From: Rusty Shaw <rusty.shaw@denbury.com>
Sent: Thursday, July 15, 2021 8:11 PM
To: -Info-Public Service Commission
Cc: Jaimee Antognazzi; Renfandt, Adam L.
Subject: Denbury ND-PSC-FPU-19-294 CHSU Lateral Pipeline Project Route Adjustment and Addition of Workspace
Attachments: pcc_doc_CHSU_MoCA_MP_11_Reroute.pdf; pcc_doc_CHSU_MoCA_MP_15_Reroute.pdf

Route adjustment to avoid recently identified buried utilities (CHSU-CL-003: MP 11.25 – 11.42)

Route adjustment to avoid recently identified buried utilities (CHSU-CL-004: Milepost 14.5 - 15.1)

Cedar Hills South Unit Lateral Project
Proposed Project Change: Reroute
 Page 1 of 1

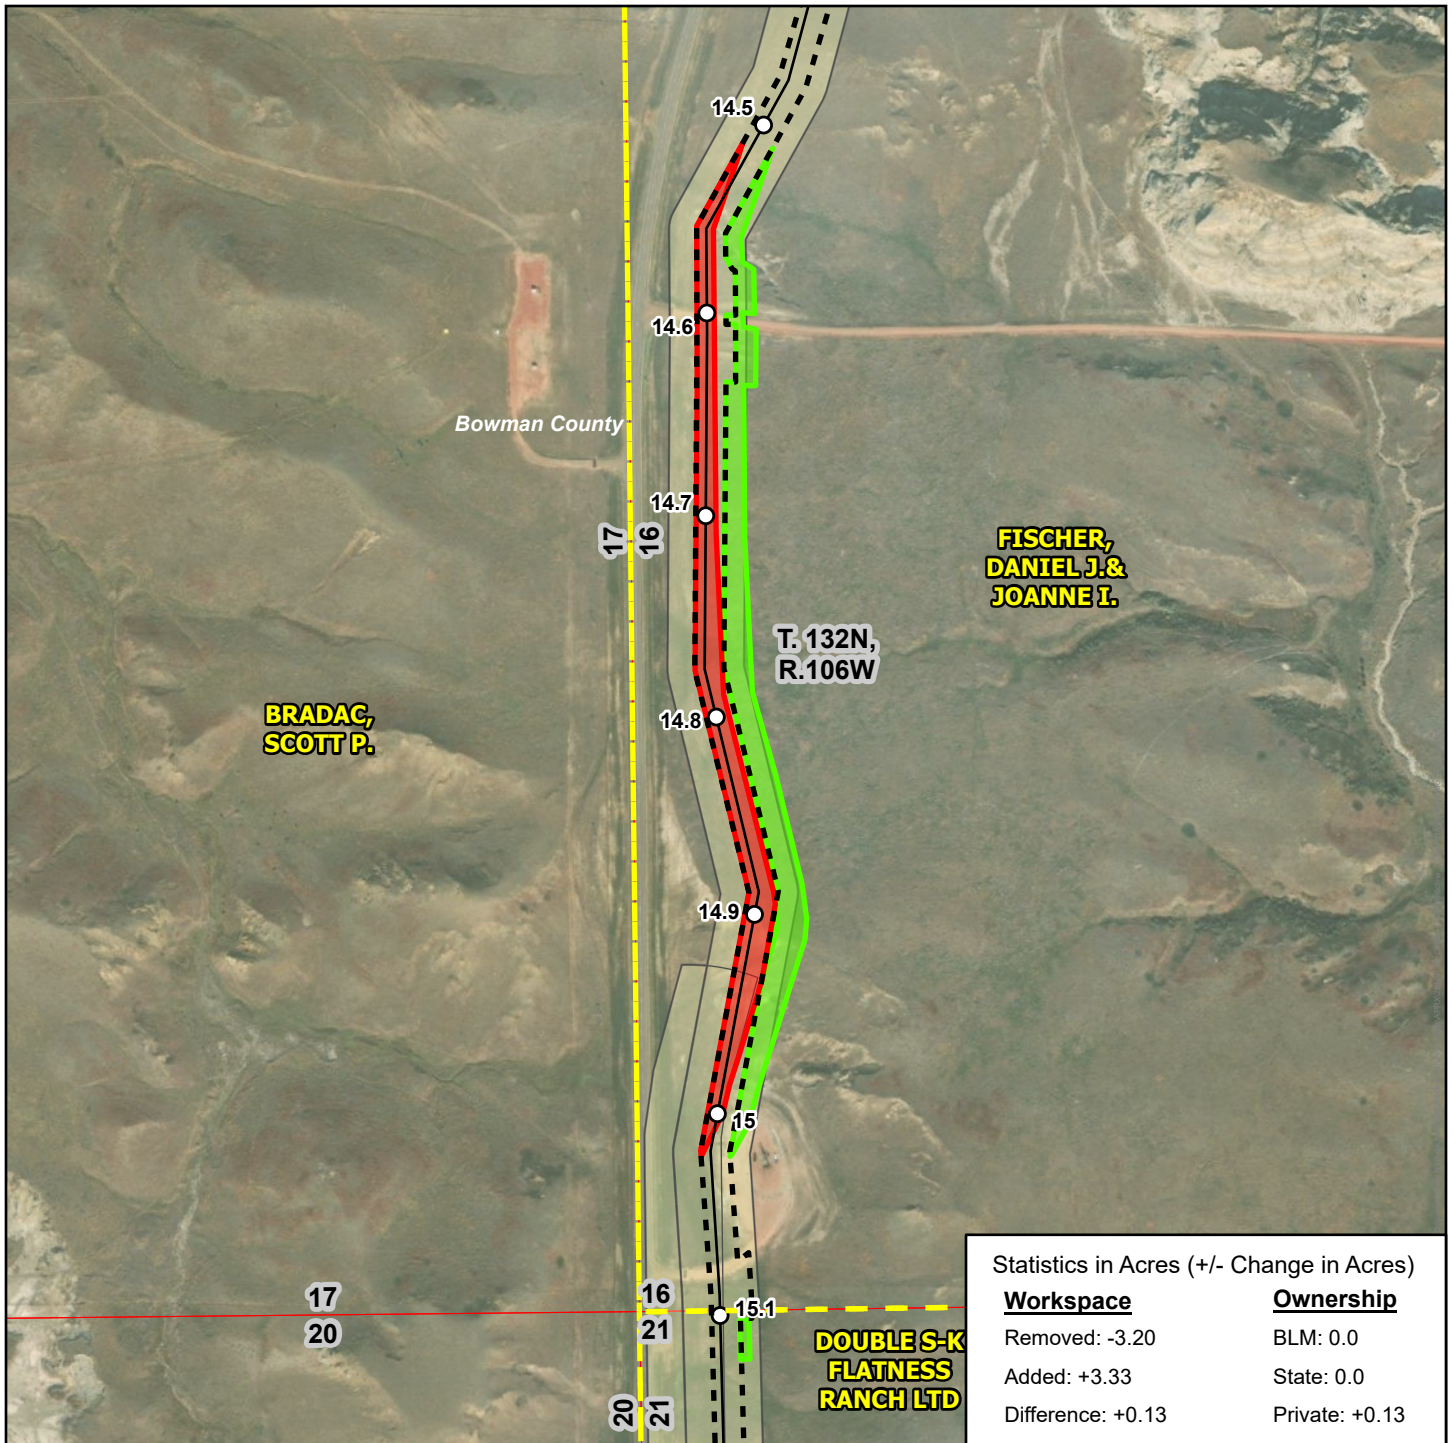
Route adjustment to the south entirely within the Hadley Brothers LLP property (see attached pdf). Length of segment is 0.18 miles.

Paleontological specialists previously field surveyed and cleared that portion of the line of resources, and due to lack of exposures it was determined additional pedestrian surveys weren’t needed for this minor route adjustment.

Natural resource specialists previously field surveyed and cleared that portion of the line of features, and a review of this reroute via aerial interpretation didn’t warrant further field surveys for this minor route adjustment.

Cedar Hills South Unit Lateral Project

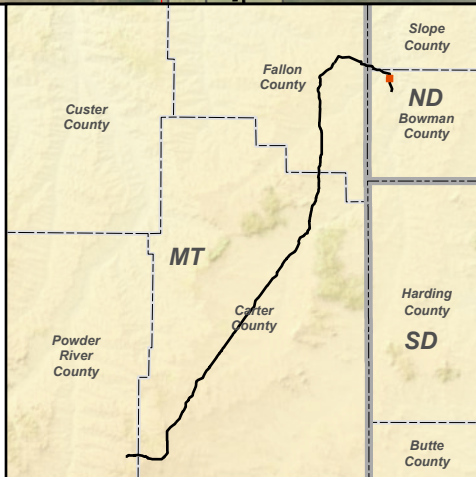
Route adjustment to the east entirely within Fischer property (see attached pdf). Length of segment is 0.5 miles.

Paleontological specialists previously field surveyed and cleared that portion of the line of resources, and due to lack of exposures it was determined additional pedestrian surveys weren’t needed for this minor route adjustment.

Natural resource specialists previously field surveyed and cleared that portion of the line of features, and a review of this reroute via aerial interpretation didn’t warrant further field surveys for this minor route adjustment.
